STATE OF MARYLAND
CRITICAL AREA COMMISSION
CHESAPEAKE AND ATLANTIC COASTAL BAYS

Re: Tebbston on the Magothy
S 02-065, P 07-0022

TEBBSTON ON THE MAGOTHY FINAL DEVELOPMENT & CRITICAL AREA PLAN

FINAL DEVELOPMENT & CRITICAL AREA PLAN ~ COVER SHEET			
TEBBSTON ON THE MAGOTHY			
SINGLE FAMILY SUBDIVISION - R1 ZONED			
SUBDIVISION NO. 2002-065		PROJECT NO. 2007-0022	
TAX MAP 24 GRID 22 PARCEL 633		DISTRICT 3RD	
ANNE ARUNDEL COUNTY, MARYLAND 21122			
SCALE: AS SHOWN	DATE: 06/30/09	PROJ. NO: TJO2599	SHEET 1 OF 8

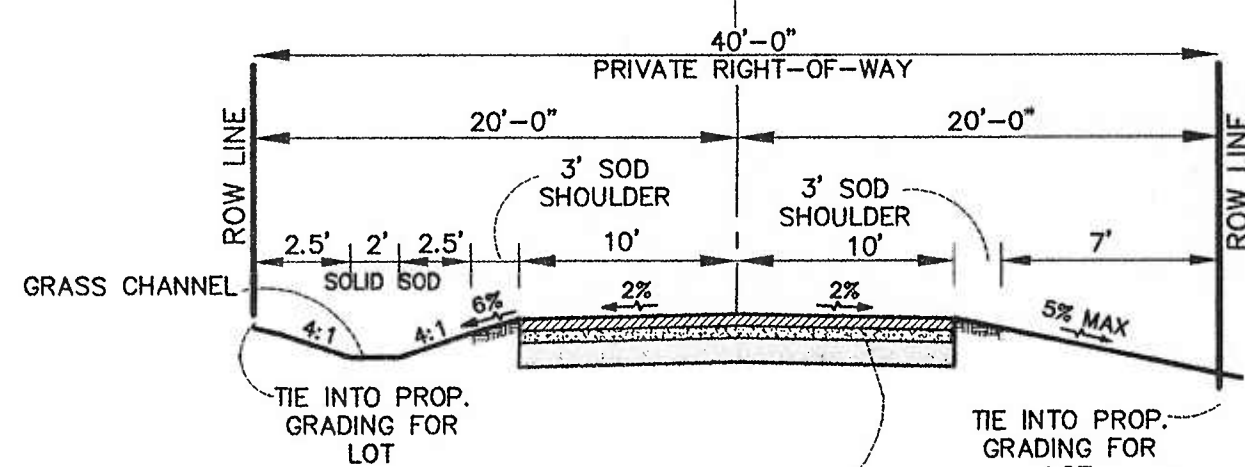
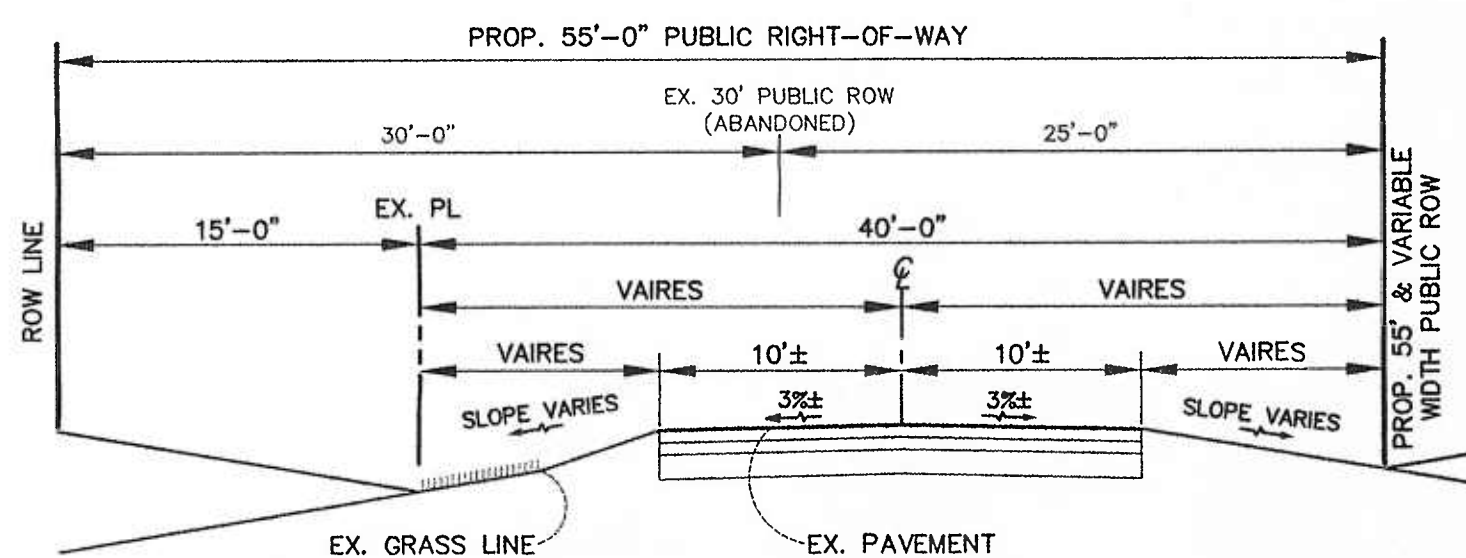
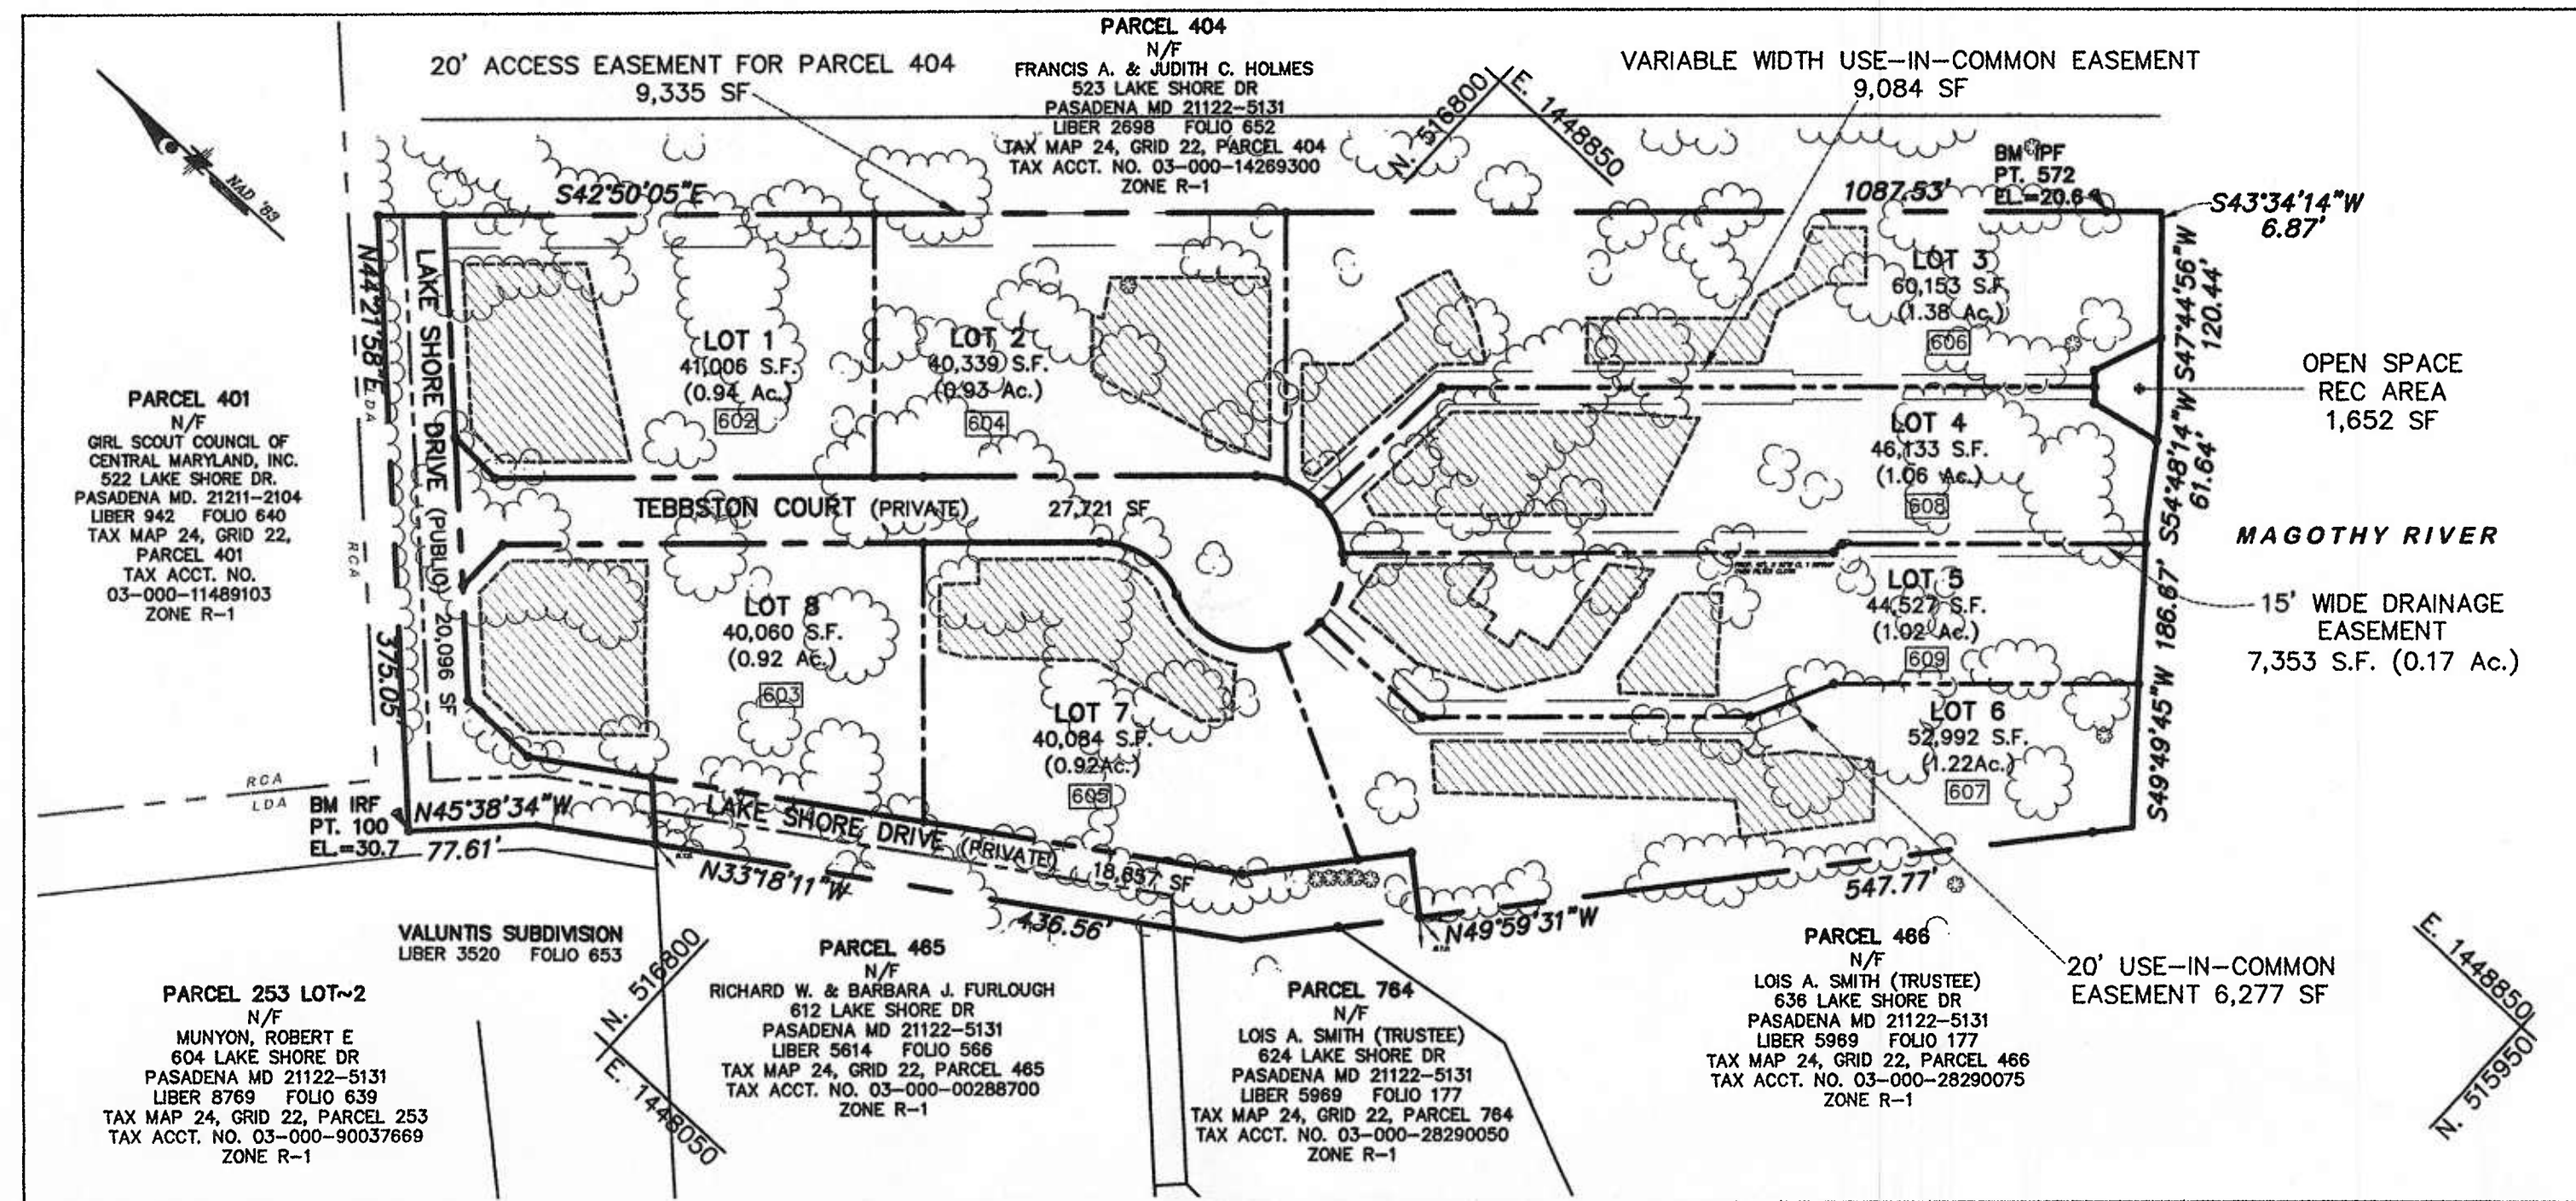
3. As requested, the applicant has acknowledged that the existing structures and lot coverage in the 100-foot Buffer will be removed in conjunction with this redevelopment proposal in note #20 on the plans. However, the wording of this note is confusing, in that it refers to the removal of all existing structures, roads, walkway, fences located "west" of the 100-foot Buffer. Please

have the applicant re-word this note so that the words "west of the 100-foot Buffer" are replaced with "in the 100-foot Buffer."

AFFORESTATION & CONSERVATION AREA PLAN
TEBBSTON ON THE MAGOTHY
 SINGLE FAMILY SUBDIVISION - R1 ZONED
 SUBDIVISION NO. 2002-065 PROJECT NO. 2007-0022
 TAX MAP 24 GRID 22 PARCEL 633 DISTRICT 3RD
 ANNE ARUNDEL COUNTY, MARYLAND 21122

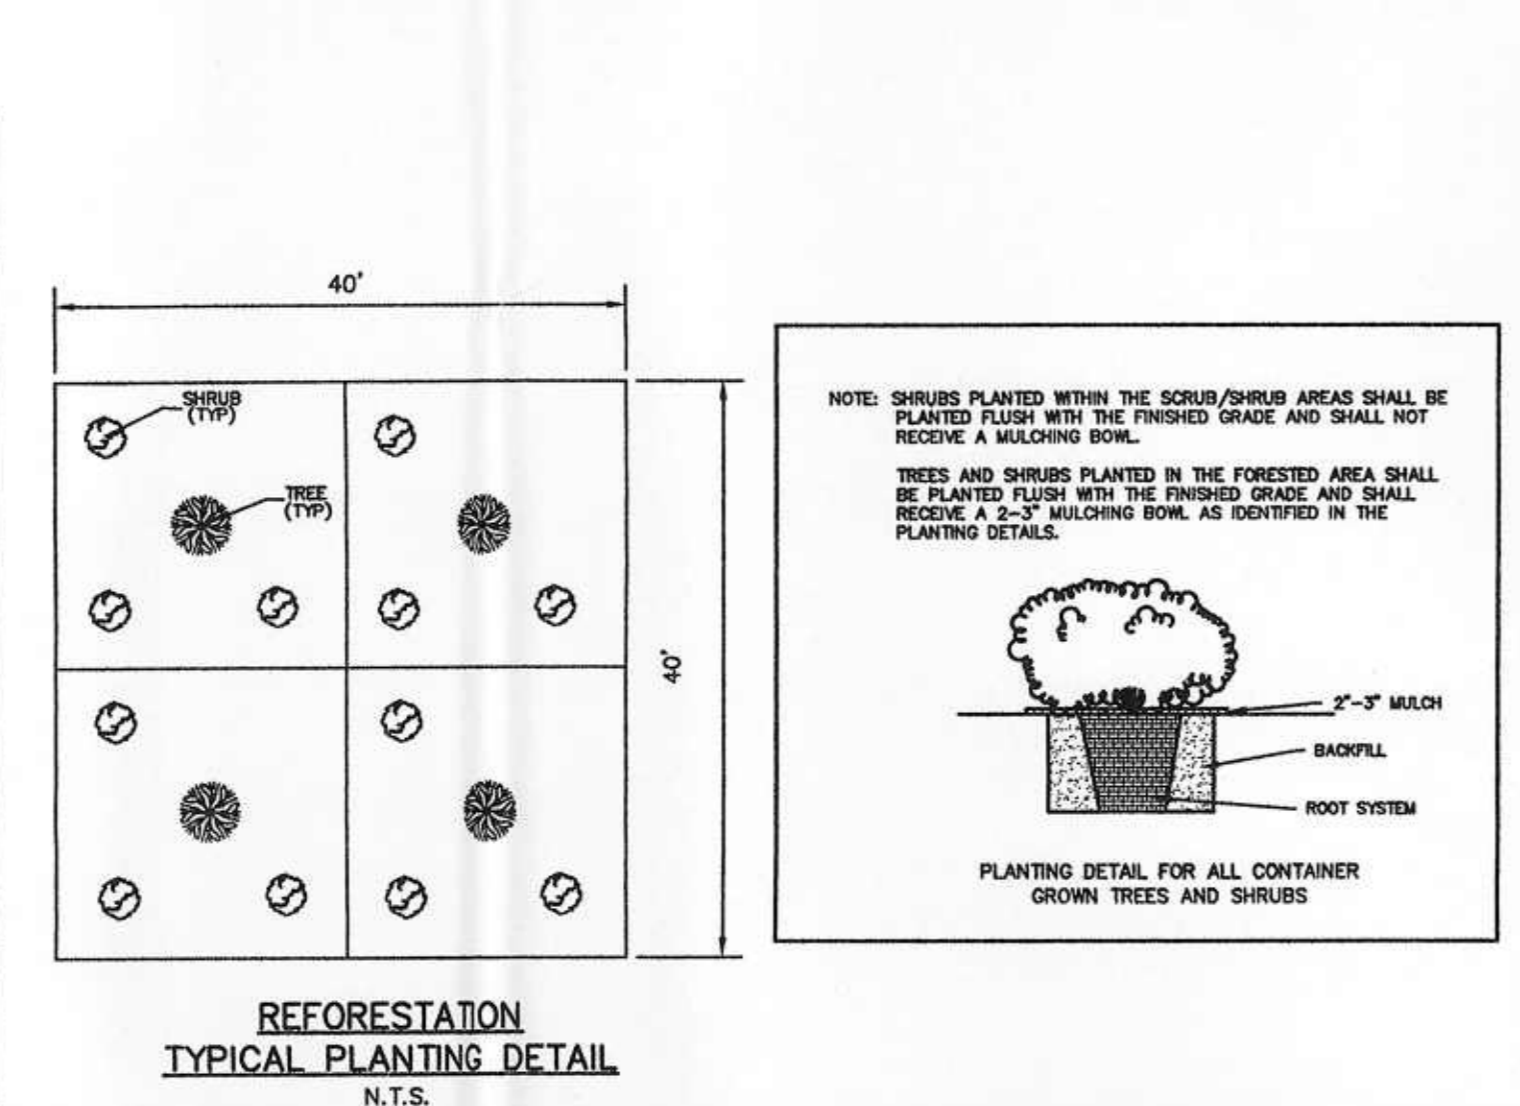
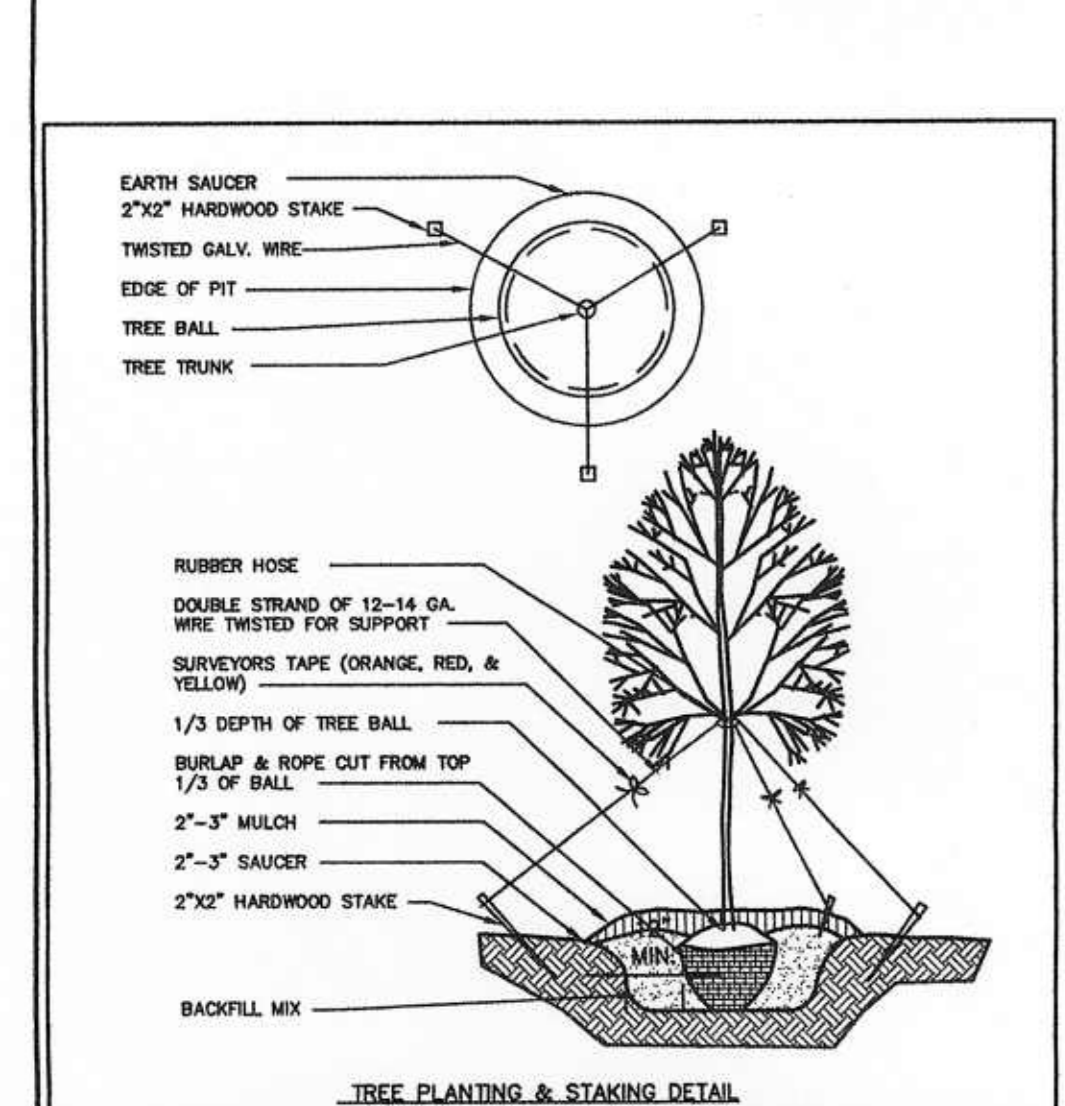
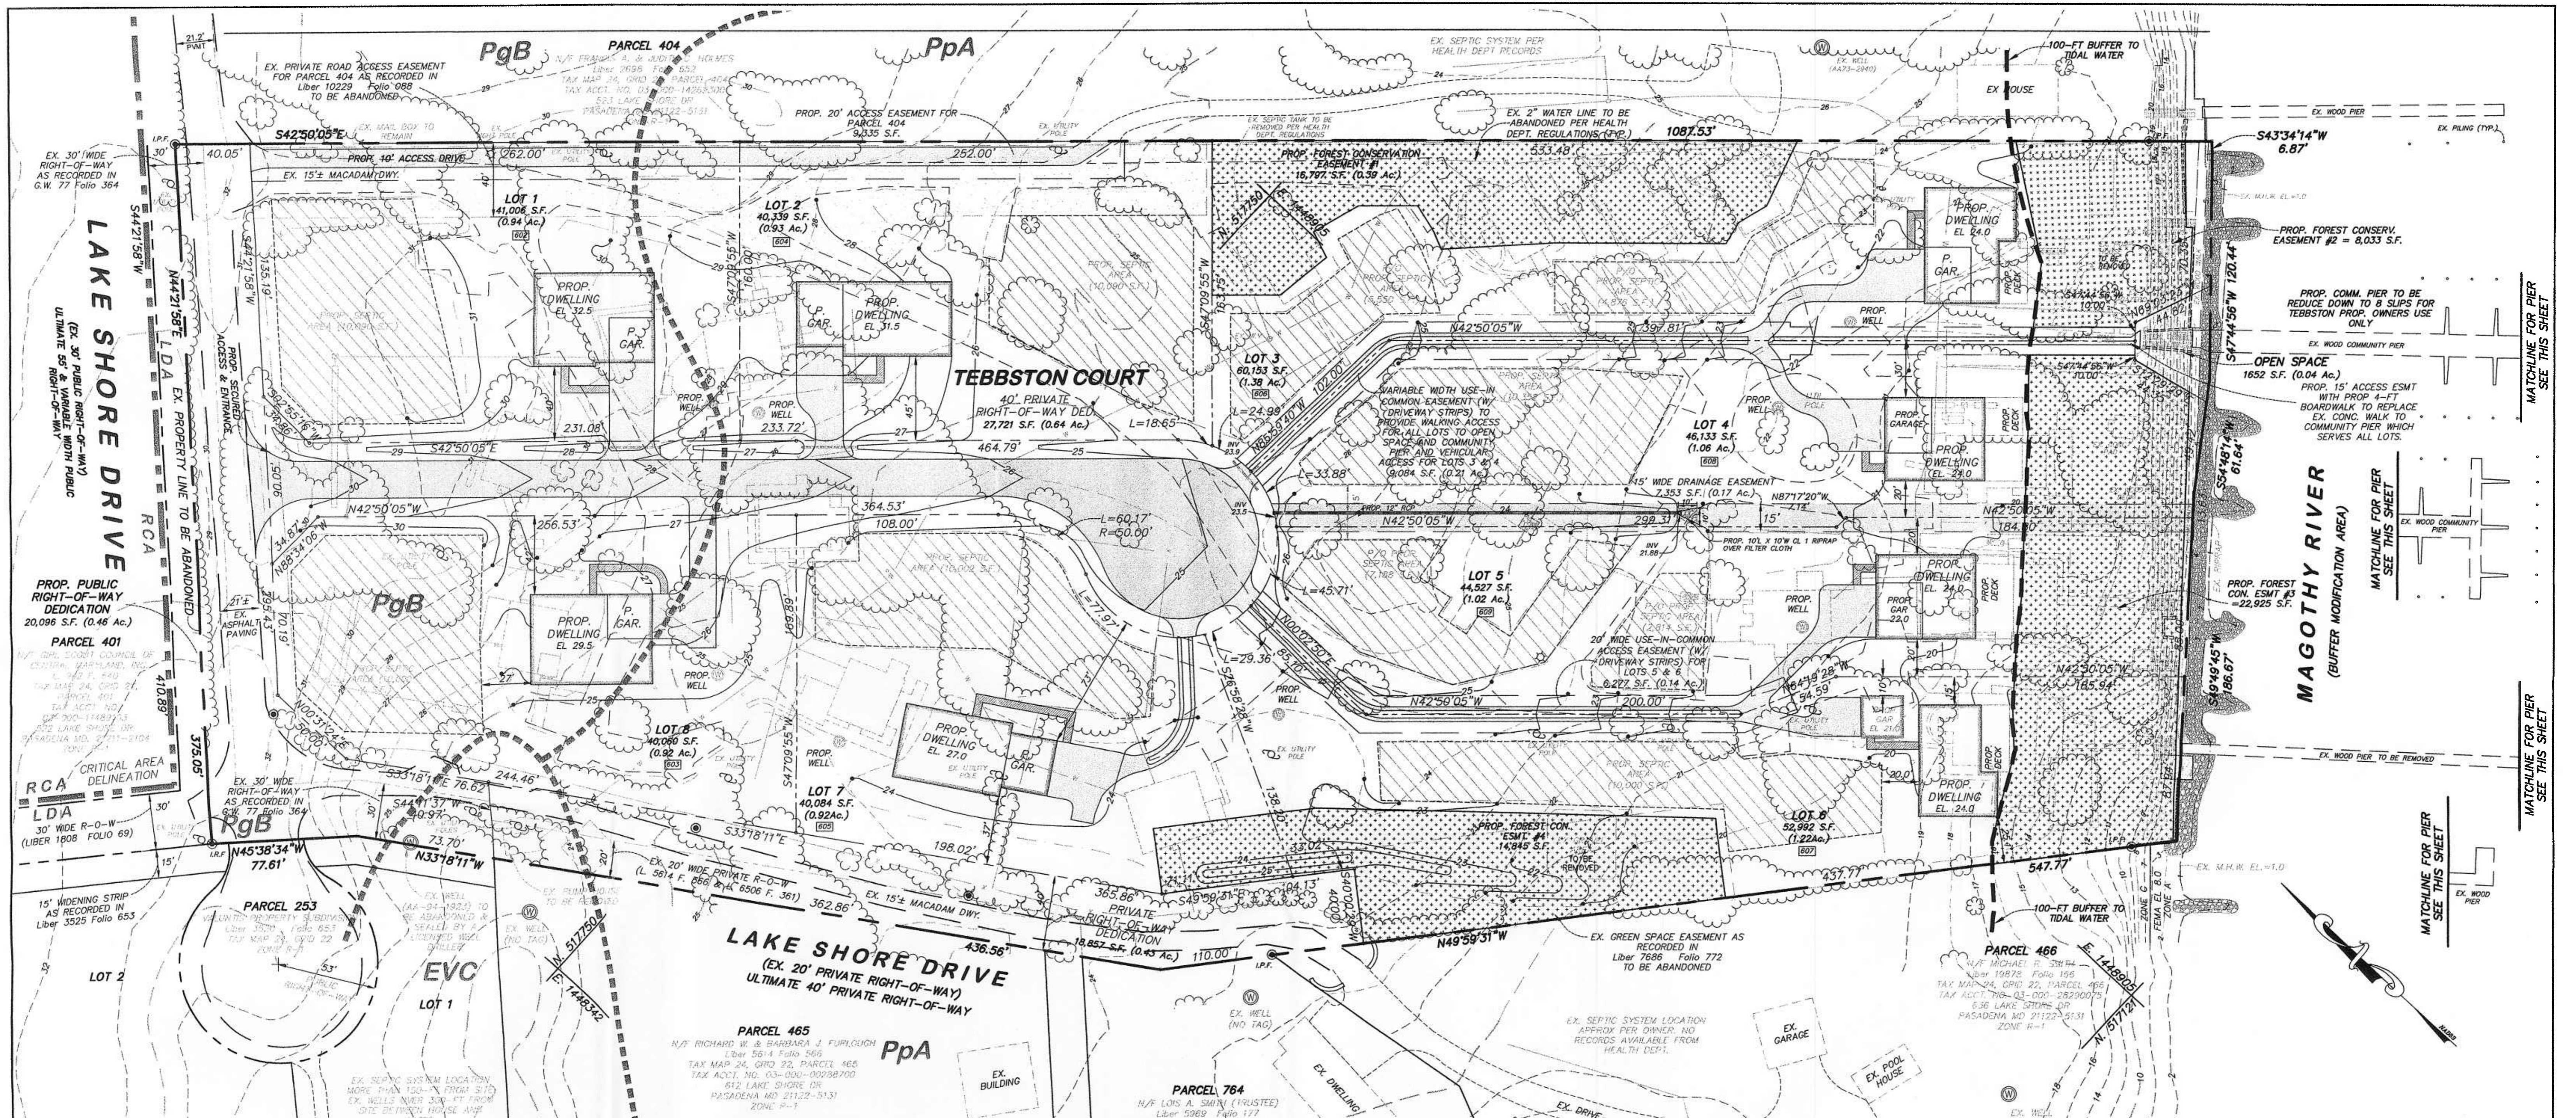
4. As requested, the applicant has quantified the existing area of tree cover and the area of tree cover to be cleared for this project. These numbers are 95,939 square feet, and 58,814 square feet respectively. However, clearing is limited by the County to 20% of the existing area of tree cover on the property, and up to 30% with permission of the Office of Planning and Zoning. No more than 30% of the existing area of tree cover can be cleared in the absence of a variance. If more than 20% of the existing area of tree cover on a property within the Critical Area is to be cleared, then the entire area to be cleared must be mitigated at a 1.5:1 ratio with replacement plantings provided on the site, offsite, or addressed by a fee-in-lieu payment if the former options are not feasible. The applicant must reduce the amount of proposed clearing accordingly.
